ADDENDUM NO. 1

Re: IM 0297(00)177, PCN 09NT

Codington County Bridge Girder Repair

GIRDER REPAIR DETAILS (D)

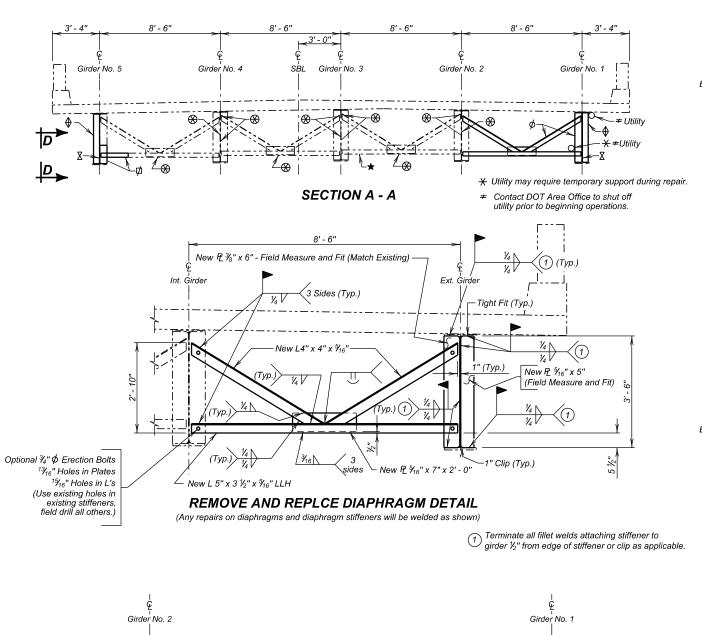
PLANS: Please destroy Sheet 21 and replace with the enclosed Sheet 21, revised 11-30-23. The

Estimate of Quantities on this sheet was corrected as the bid items did not properly

match the units or quantities.

ESTIMATED QUANTITIES			
ITEM	UNIT	QUANTITY	
Remove Structural Steel Member(s)	LS	Lump Sum	
tructural Steel, Install LS Lump		Lump Sum	
Remove and Replace Web	Each	3	
Remove and Replace Transverse Stiffener	Each	3	
Remove and Replace Steel Diaphragm	Each	1
